# D/DRC Case

1030 Gregg Street

**DESIGN/DEVELOPMENT REVIEW COMMISSION**  
**DESIGN REVIEW DISTRICT**  
**HISTORIC AGENDA**  
**EVALUATION SHEET**  
**Case # 3**

**NATURE OF REQUEST:** Request Certificate of Design Approval for exterior changes

Red arrow indicates vent and trim that are proposed to be removed.

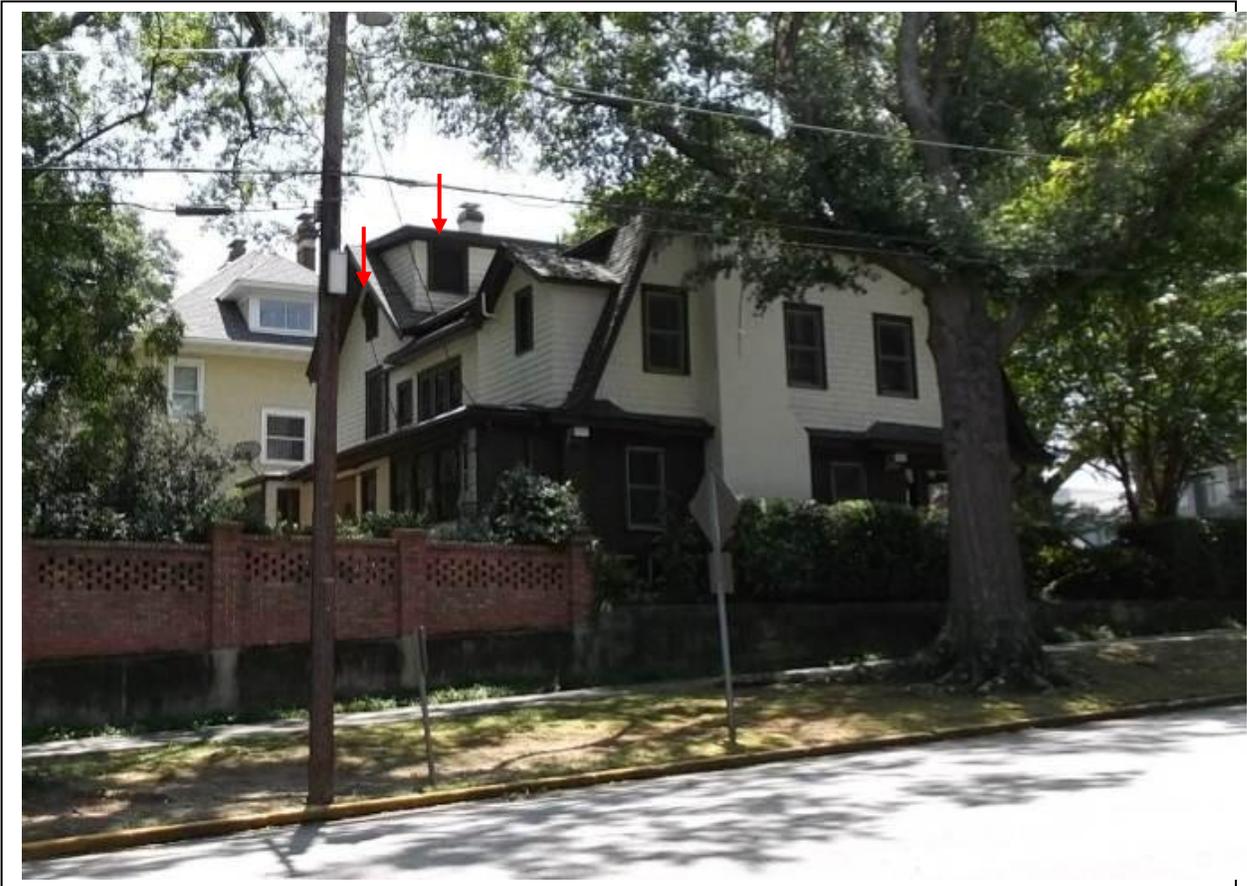
This building has a variety of decorative wood elements. Each component is integral to the overall design of a very complex exterior. Square and rectangular shapes contrast with sloping features and the focal point of the entrance, an arch. This arch motif is only replicated in the south and east attic vents, and is exaggerated by a heavy shroud of trim made up of wood shingle, matching the exterior siding, with a decorative keystone. One of the most detailed adornments for any openings on the building, these are essential components of the building's appearance. The proposal is to remove the trim and enlarge the vent opening to accommodate a new single lite window and install new trim as shown in the attached drawings. Removal of this original trim would not meet the guideline, which states that such features are to be retained.

The horizontal wood slats of the three attic vents are also components of the exterior wood materials that should be retained. Historic wood vents help to show the observer how the building's interior space was originally configured and how its utilitarian elements such as venting were incorporated into the architectural design, which is done particularly well on this building. Often overlooked, historic vents are also elements that can help date a building, as they changed shape and location as styles evolved over time. According to the guideline, these elements should be retained. The proposal for single lite windows with no grids in these openings is in stark contrast to the existing historic vents and does not meet this guideline.

Staff finds that the proposal to remove original vents and trim, enlarge openings and install visible windows does not meet Section 6 of the guidelines and recommends that the request be denied.

Should the City's plans examiner conclude that the attic space can be converted to bedroom space and therefore require a means of egress, then only one is required, meaning not all three vents would need to be converted. The most logical location for a conversion would

be the rectangular vent in the rear shed roofed dormer, which faces the street. This opening is already larger than the two arched vents. The vent could be retrofitted to hinge out for egress and an interior window behind the vent could be attached to the hinge mechanism or installed independently.

To achieve a sealed space for heating and cooling, glass panels could also be inserted behind the existing vents. These would be invisible from the public right of way and would allow the original vents and trim to remain intact.

Staff can work with the applicant to pursue hidden window features behind the vents should they wish to pursue that option.
